Serial No.: 10/699,604

**In the drawings:**

## REMARKS

FIG. 2

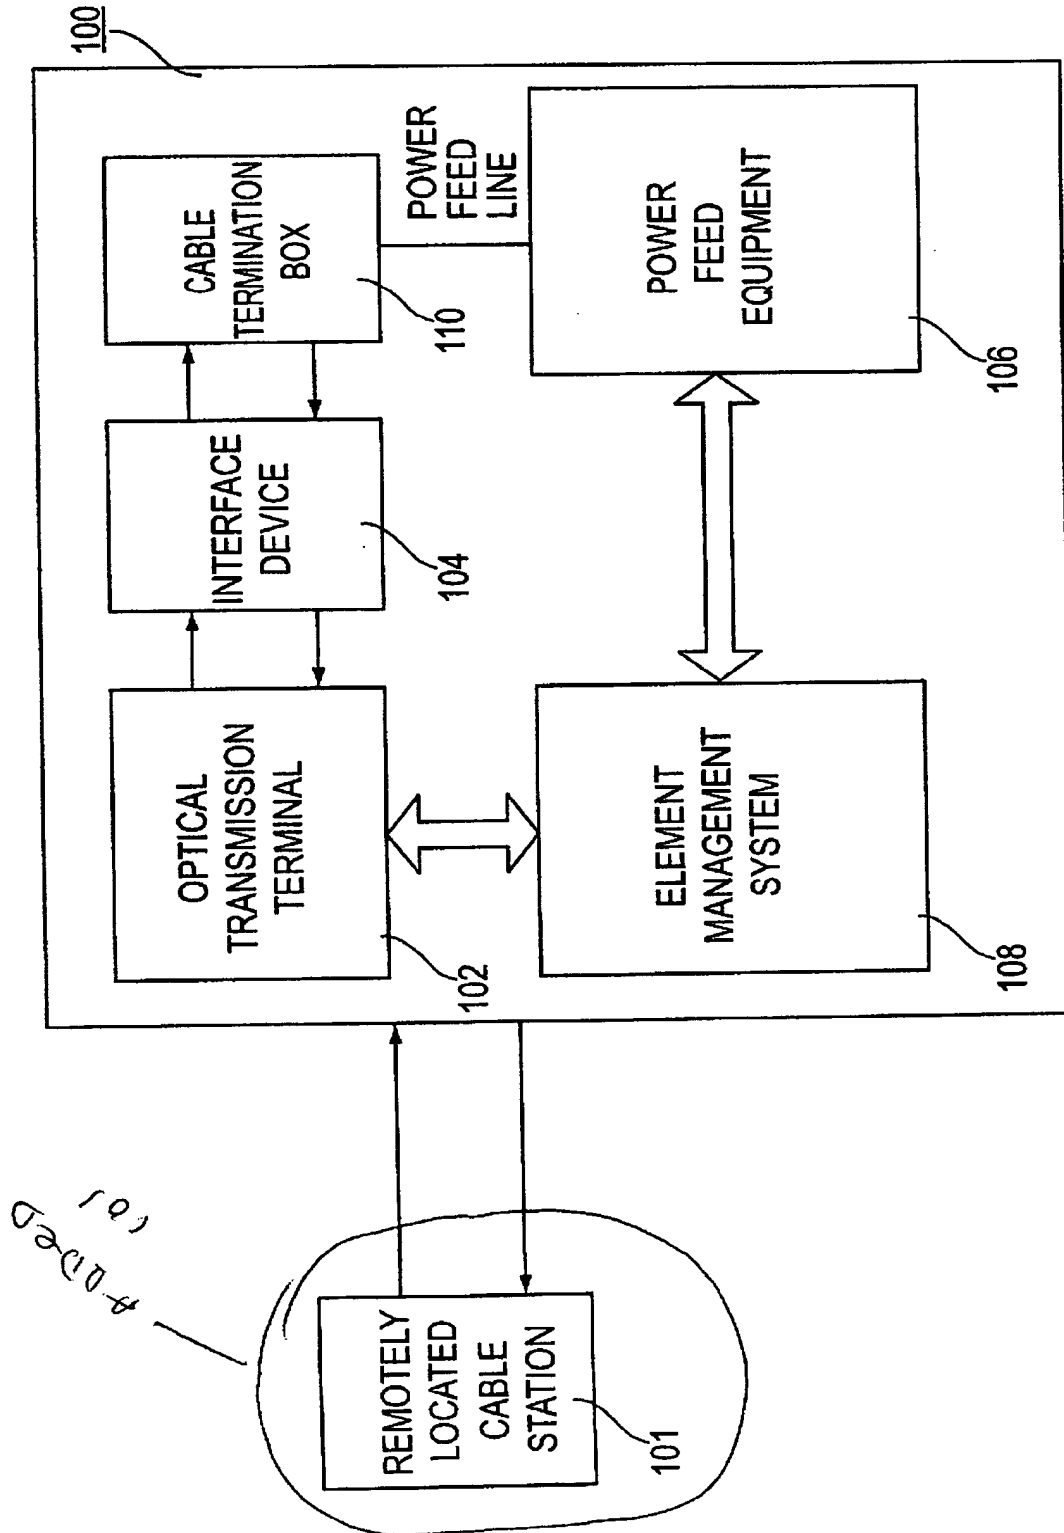
Per the Examiner's requirement on Page 2 of the Office Action, corrected drawing sheets 2/4 and 4/4 in compliance with 37 CFR 1.121(d) are filed herewith. These sheets have been labeled "Replacement Sheet". Per the Examiner's requirement, the specific changes include the addition of a remotely located cable station to Fig. 2 and a Raman pump source to Fig. 4. A copy of the original drawing sheets indicating the desired changes are filed herewith as well.

ANNOTATED SHEET

FIG. 4

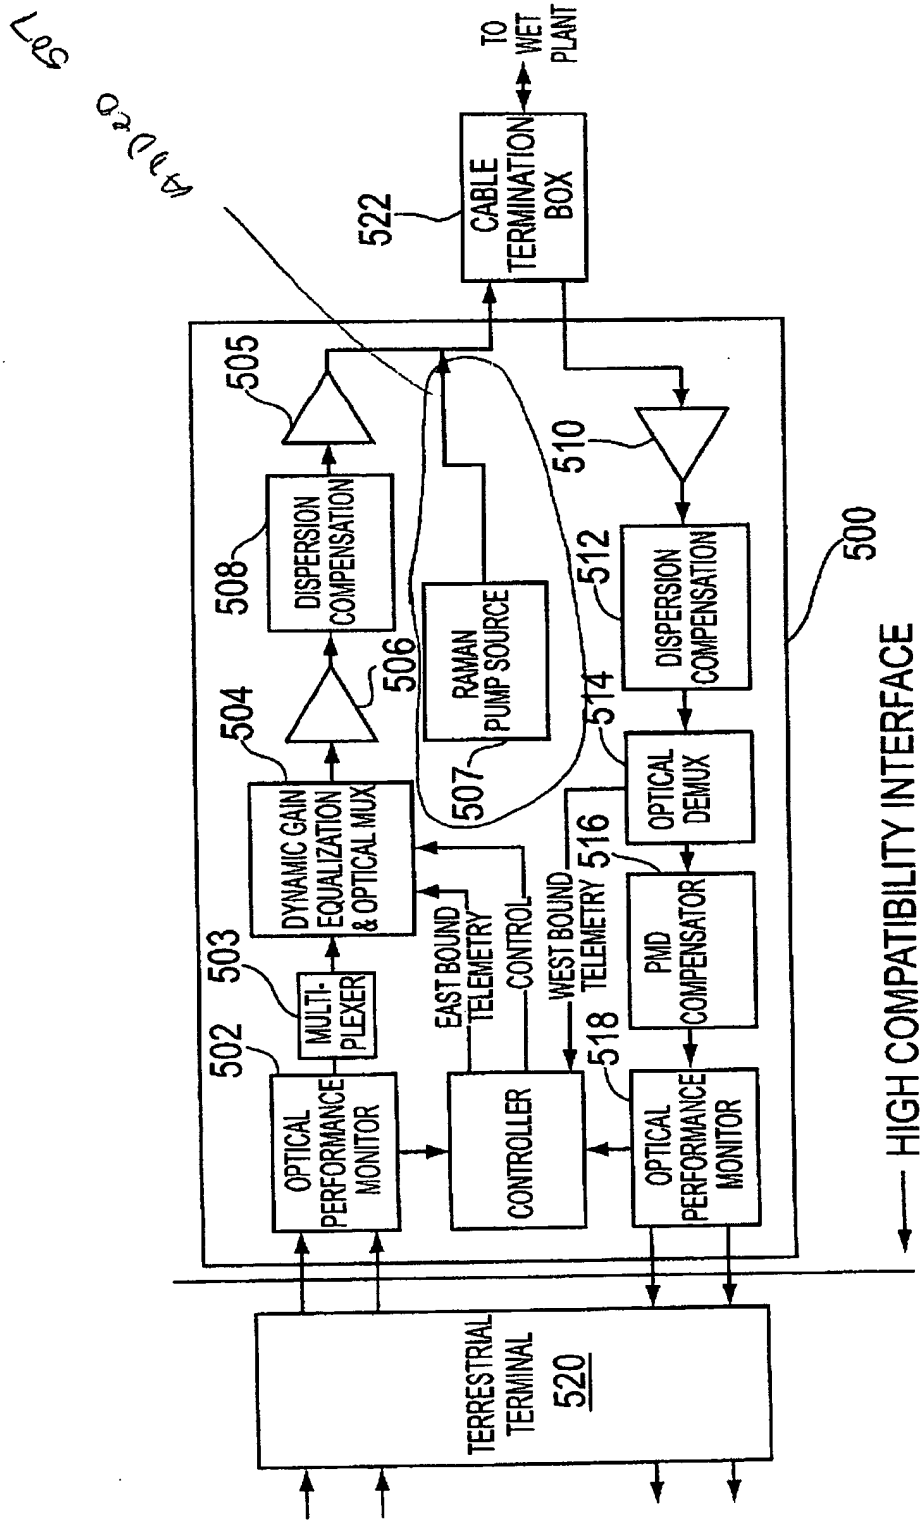
ANNOTATED SHEET
